PCN 客户确认通知单
PCN customer confirmation Notice

PCN NO#: 15052601

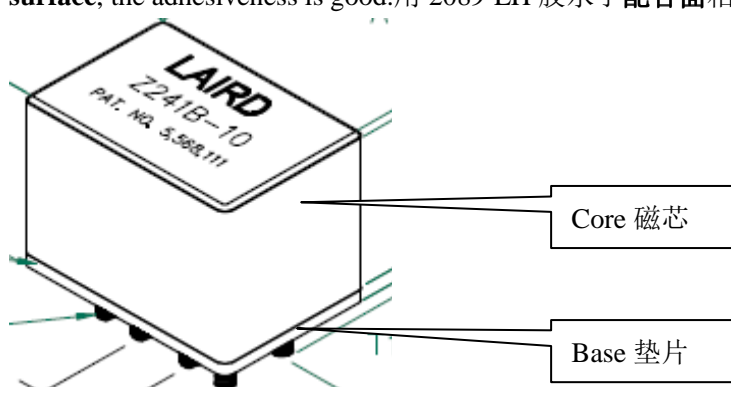
产品型号 Part No.	CM5740Z241B-10	提出日期 Submission date	2015-05-26
变更内容 Change content	Change the glue from G500 to 2089-LH to increase the adhesiveness of plastic case to core.改 G500 胶水为 2089-LH 胶水增强磁芯与垫片的粘合效果 Before change 变更前: use glue G500 to paste the base and the core by sidewall , the adhesiveness is not good 用 G500 胶水在 侧面 粘合磁芯和垫片, 粘合效果较差 After change 变更后: use glue 2089-LH to paste the base and the core by mating surface , the adhesiveness is good.用 2089-LH 胶水于 配合面 粘合, 粘合效果较好		
	 <p style="text-align: right;">Core 磁芯</p> <p style="text-align: right;">Base 垫片</p>		
变更类型 Change type	<input type="checkbox"/> 规格变更 SPEC change <input checked="" type="checkbox"/> 生产方法变更 method change <input type="checkbox"/> 生产机器变更 machine change <input type="checkbox"/> 包装方法变更 package change <input type="checkbox"/> 生产环境或生产地点变更 Environment or production location change		
变更前数据对比 Before change contrast after change

对比项目 Contrast items	变更前 Before change	变更后 After change	
品质数据 Quality data	G500	2089-LH	
有害物质含量测试 HS test	pass	pass	
结论 Conclusion	Change the glue from G500 to 2089-LH
